Project No. 24-09  
CJUSD Central Freezer Facility

**Center Joint Unified School District  
CJUSD Central Freezer Facility @ M&O Yard  
Project No. 24-09  
8408 Watt Avenue, Antelope, CA 95843**

## ADDENDUM NO. 1 - 4/29/2024

**ADDENDUM NO. 1** 4/29/2024

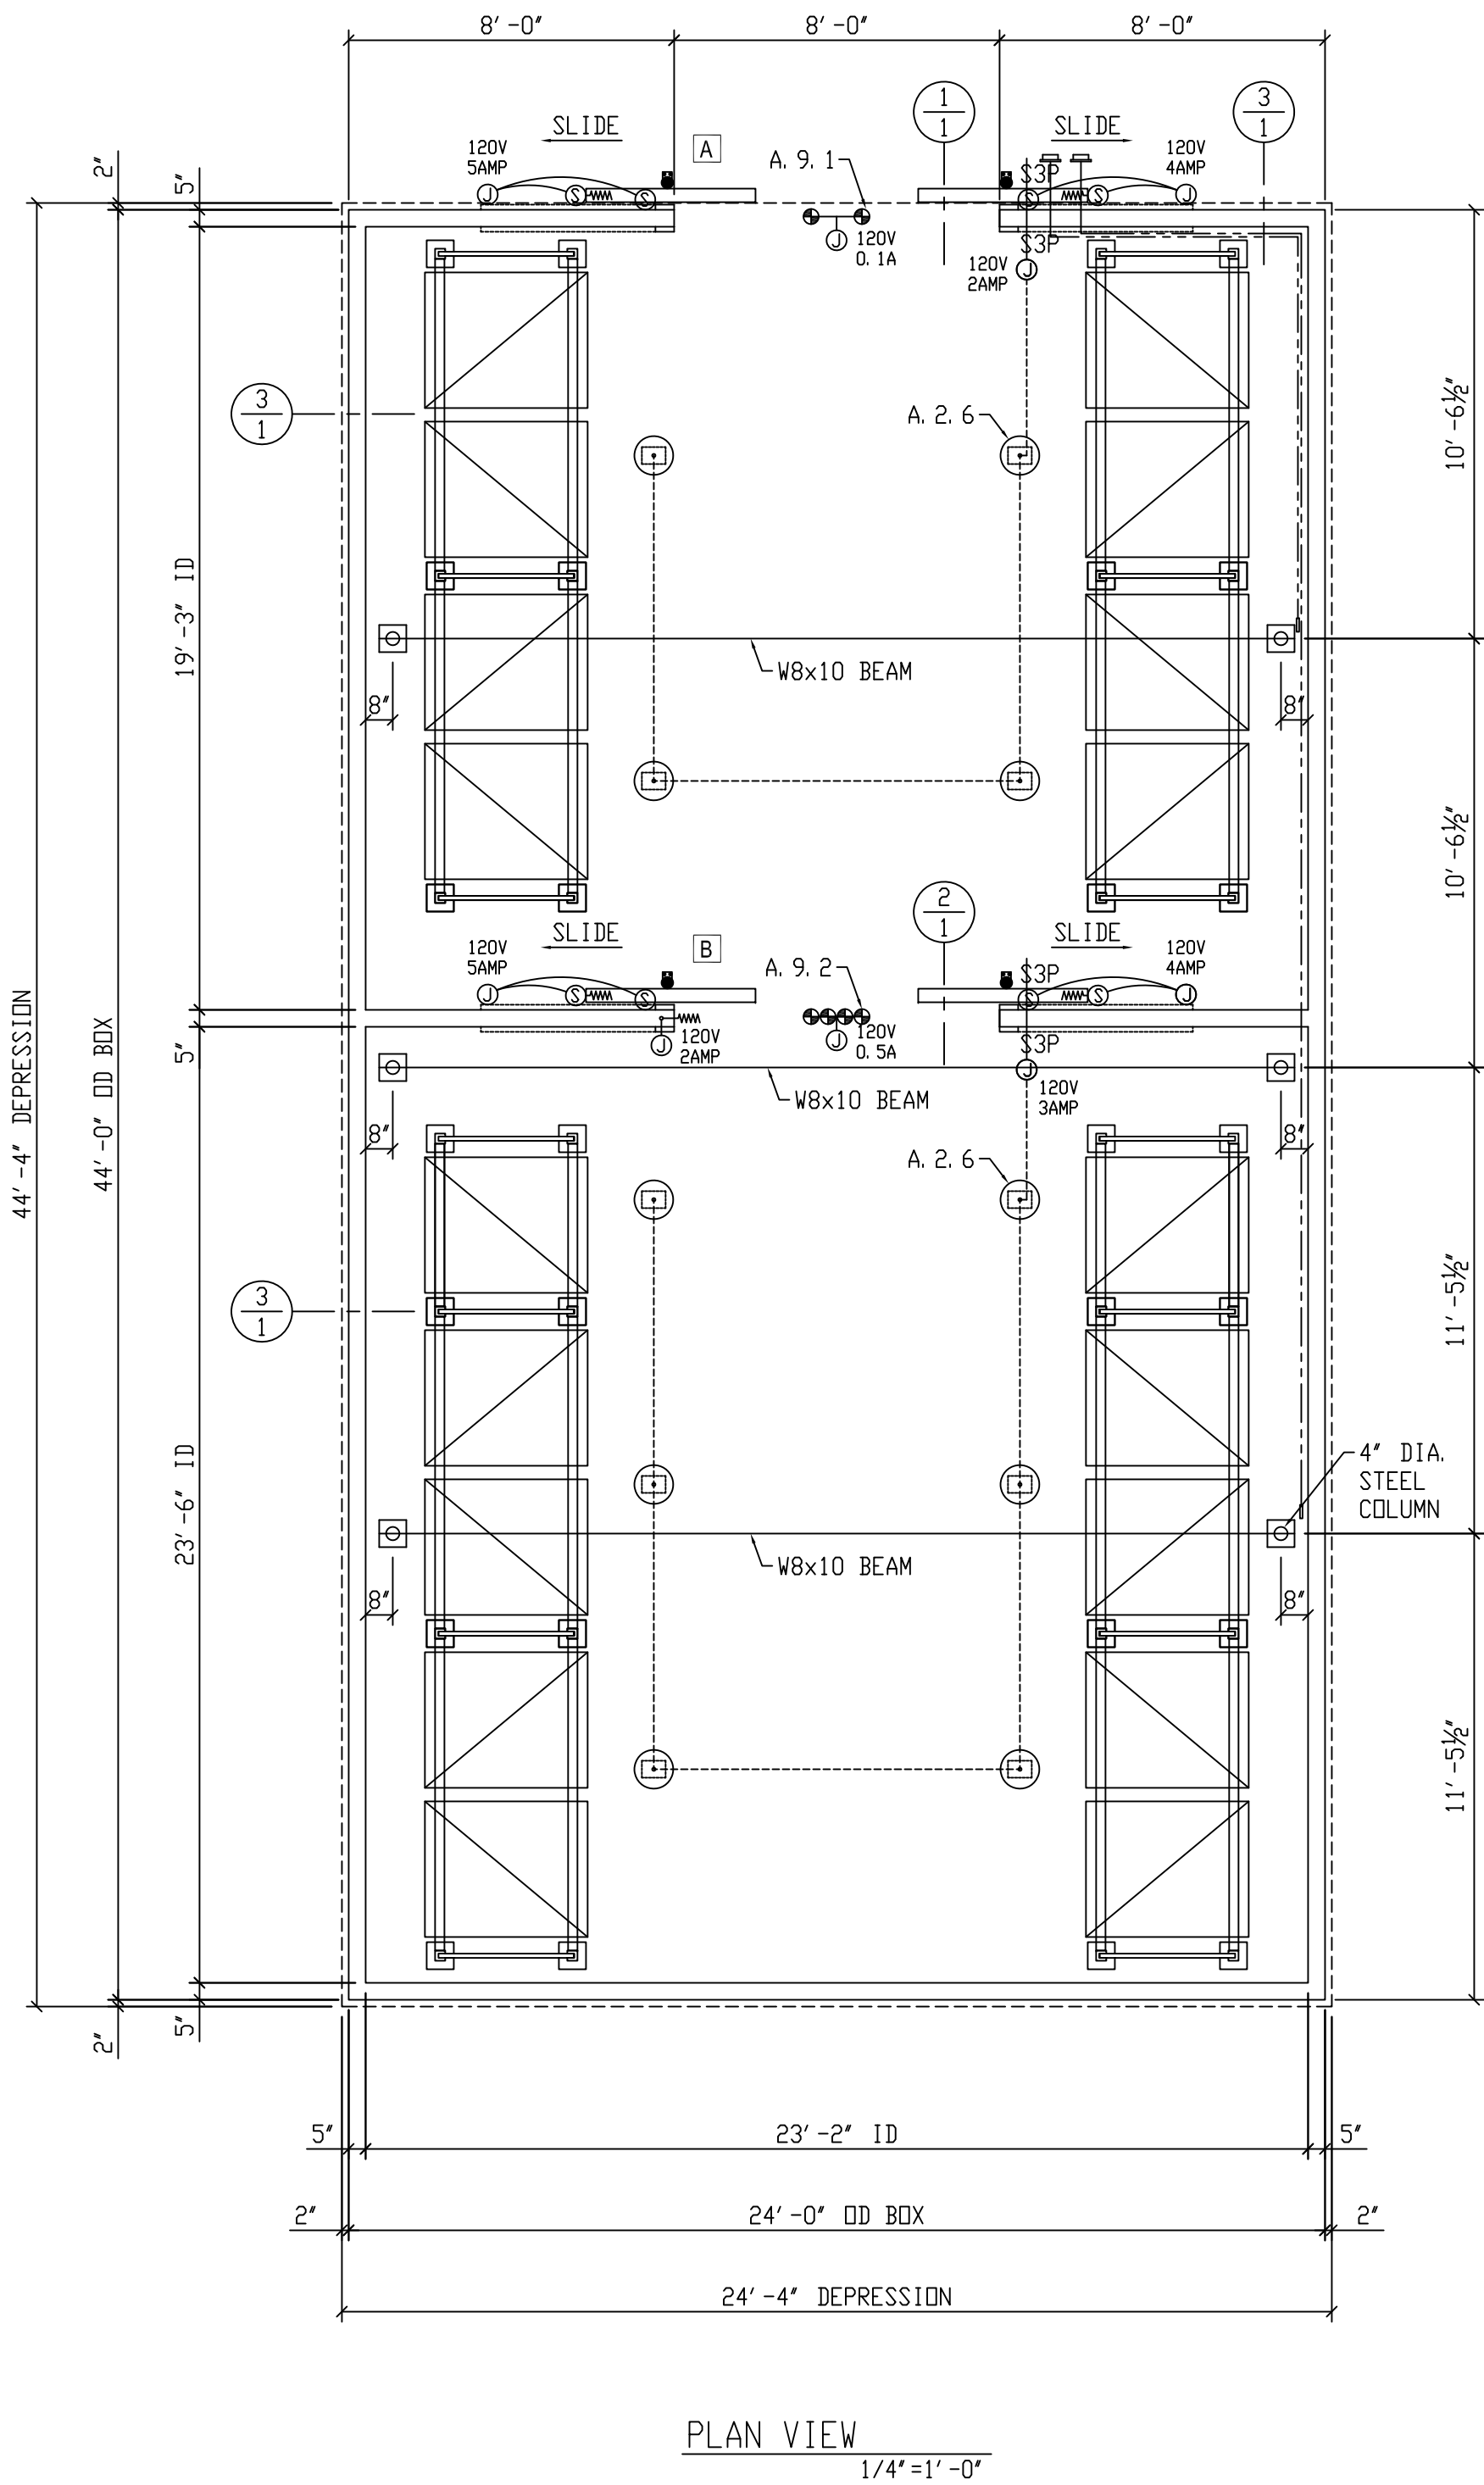
- New sheet added - See attached.
- Note - While this sheet is primarily for reference for RMI/Airdyne provided and installed equipment, some site development work is identified on this sheet.
